To: **Planning Commission**
From: **Melissa Sonnek, Community Development Coordinator**
Date: **November 20, 2018**

Site Plan Review for the Expansion of 1740 Charlton St

On behalf of School District 197, Anderson-Johnson Assoc., Inc. is requesting Site Plan approval to allow for the expansion of the existing school building located at 1740 Charlton St.

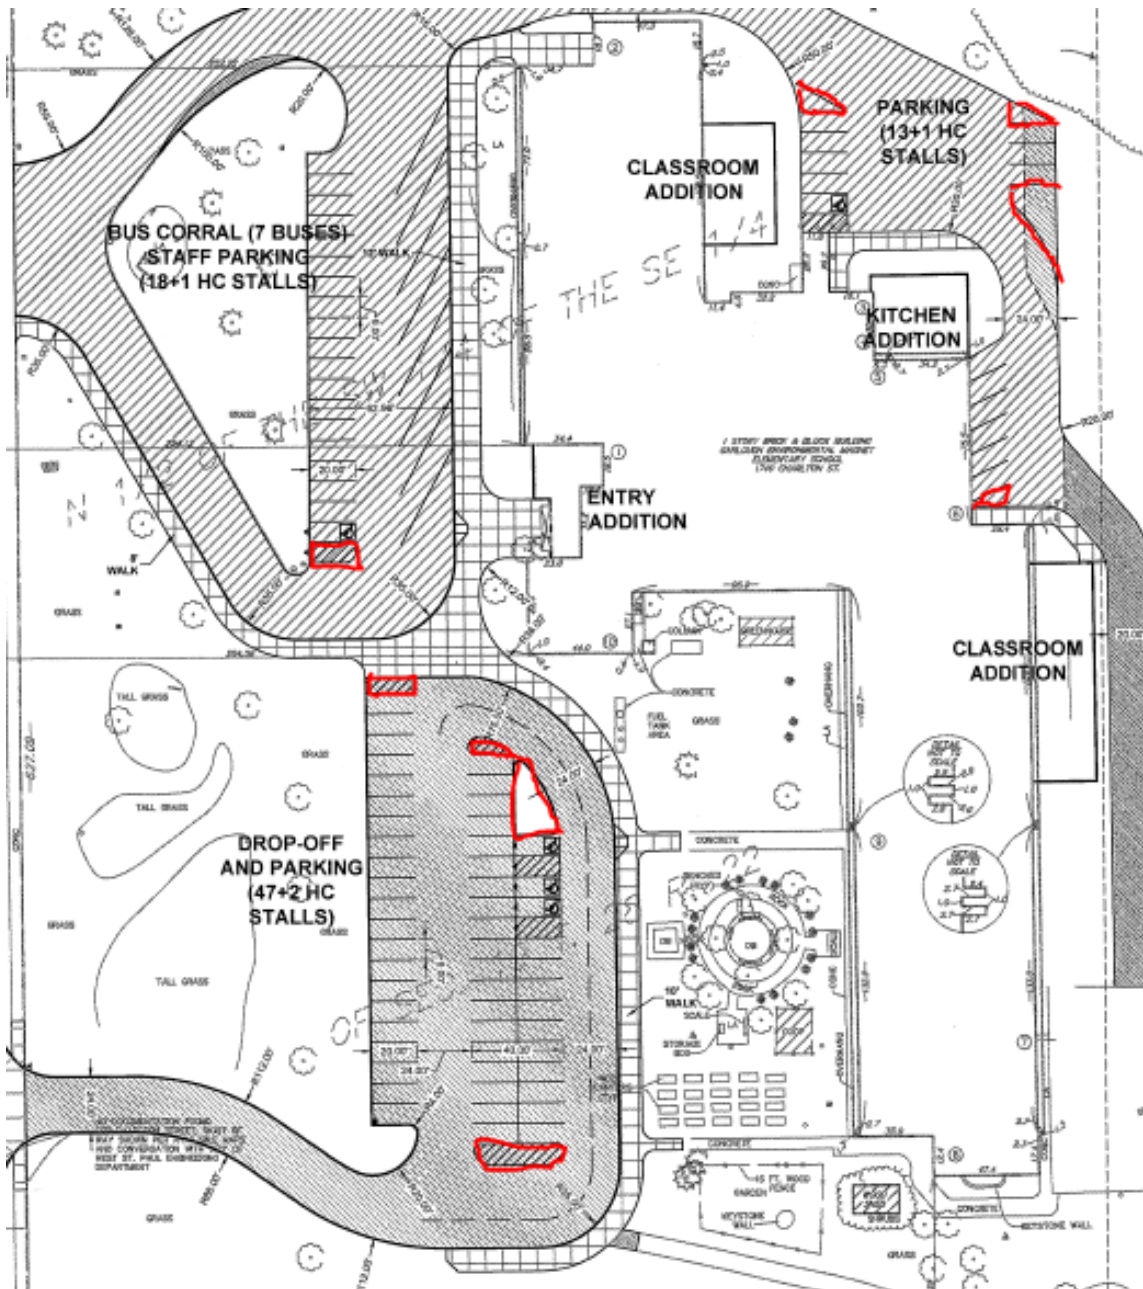
The Zoning Ordinance section 153.031(D)3b requires that curbed islands must be placed at the end of every row of parking. The site plan shows some of the parking rows capped by striping; however, striping does not satisfy the ordinance requirement. Therefore, Staff is recommending as a condition of approval that a curbed island be added to the end of each row of parking as shown below in red.

1. The applicant shall apply for and obtain all applicable building and sign permits. If any new signage is proposed, the signage shall meet the requirements of Section 153 of the Zoning Ordinance,
2. The applicant shall place curbed islands at the end of every row of parking,
